CEDAR KEY WATER AND SEWER DISTRICT
INVITATION TO BID NO: 2024-02
SANITARY SEWER LIFT STATION REHABILITATION
ADDENDUM NO. 1

April 22, 2024

The following changes have been made to the plans & specifications for the above project:

**STANDARD DETAIL
FOR LIFT STATION 1 & 7
IMPROVEMENTS**

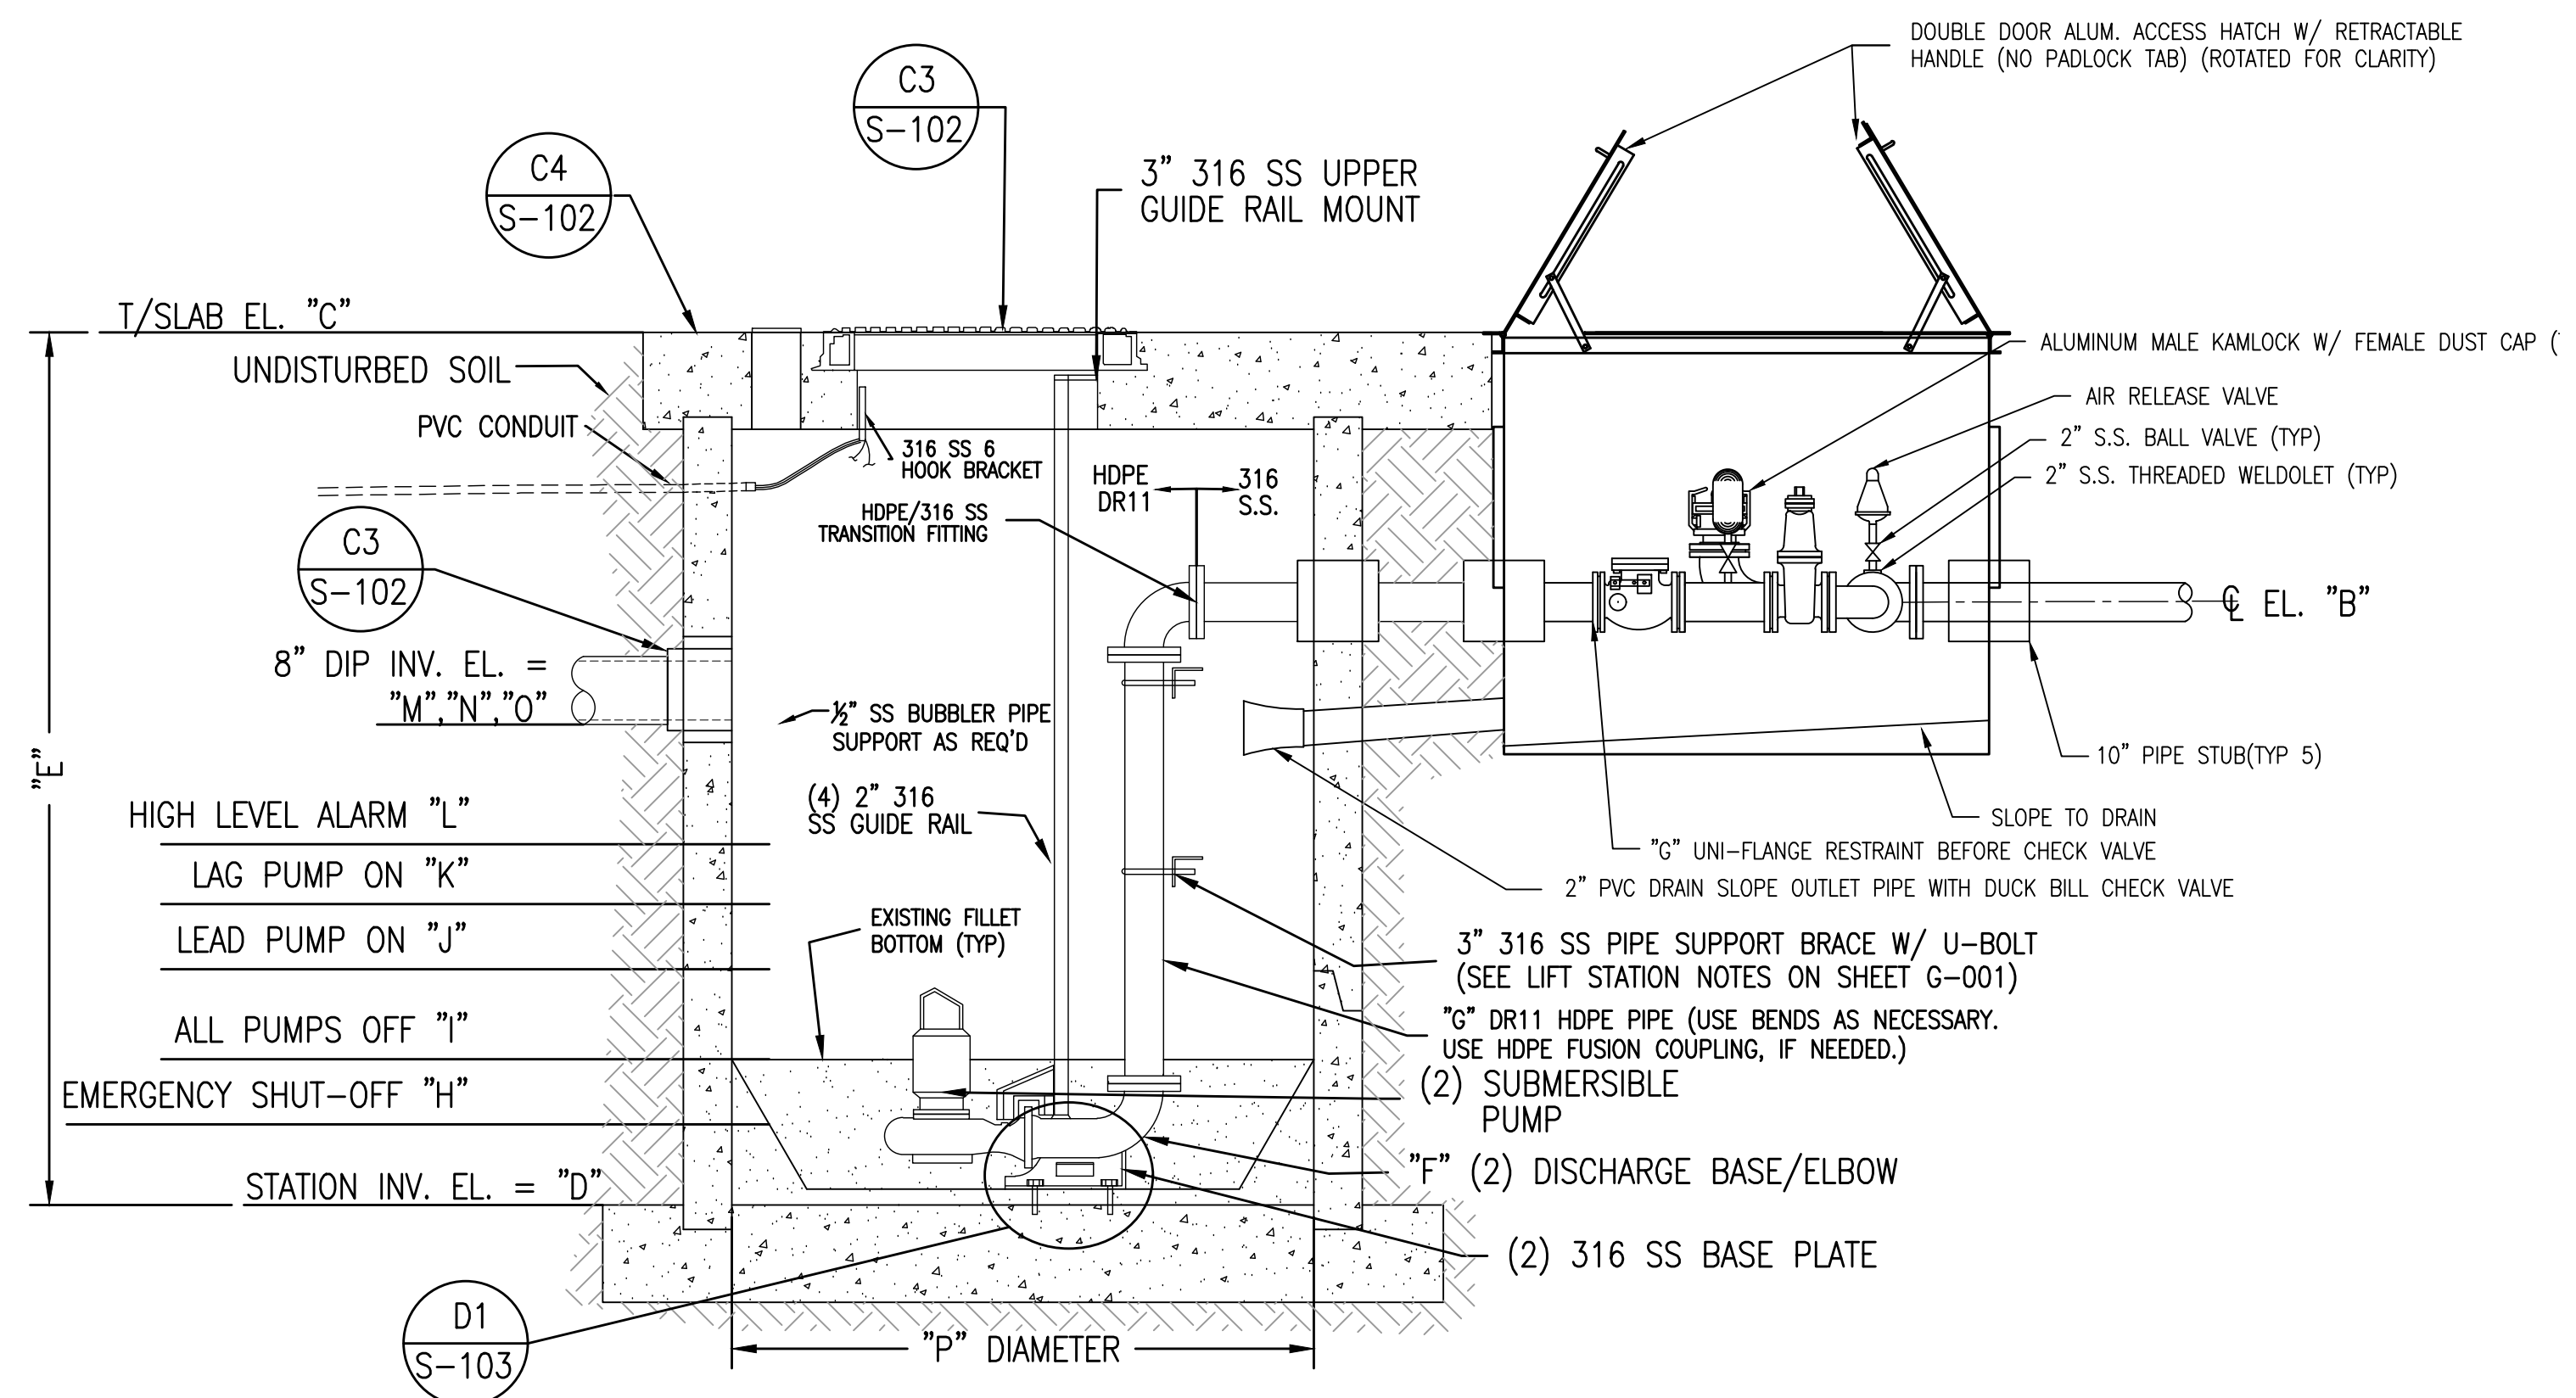
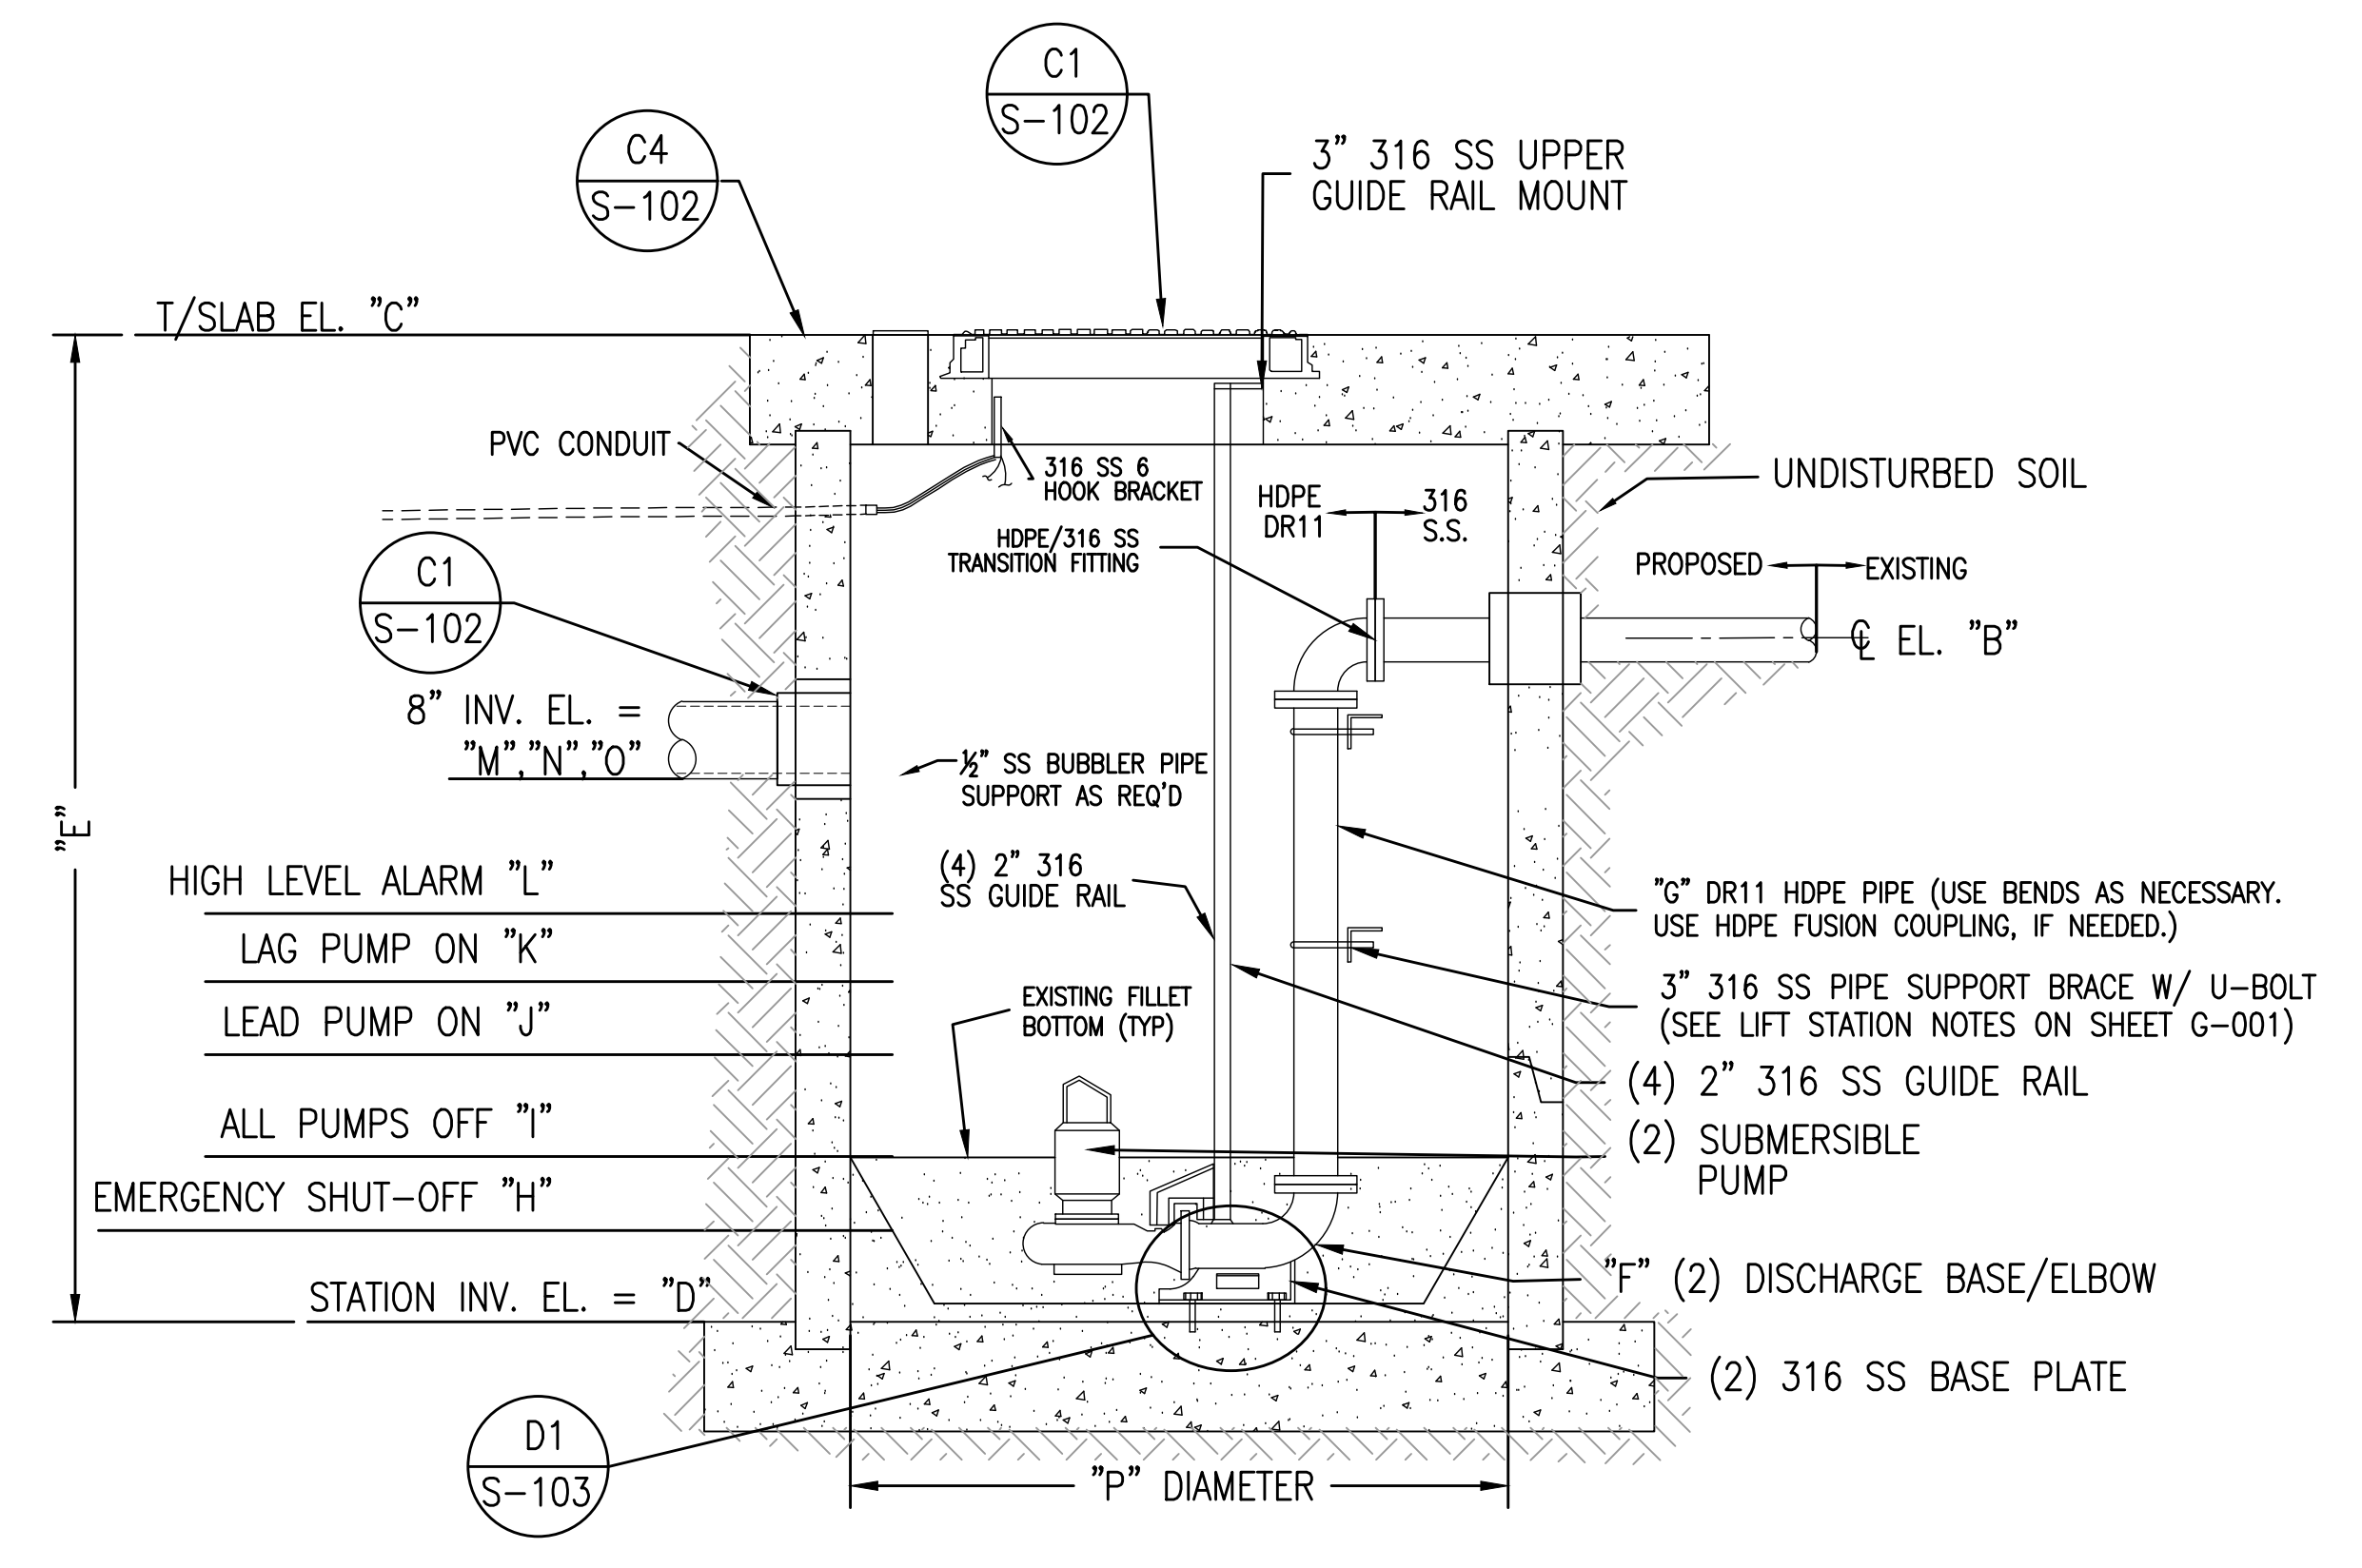
M-903	Updated drawing to include a 4” SS J-Vent Detail
E sheets	All electrical drawing sheets associated with the Sanitary Sewer Lift Station Rehabilitation project are provided with Addendum #1.
S sheets	All structural drawing sheets associated with the Sanitary Sewer Lift Station Rehabilitation project are provided with Addendum #1.
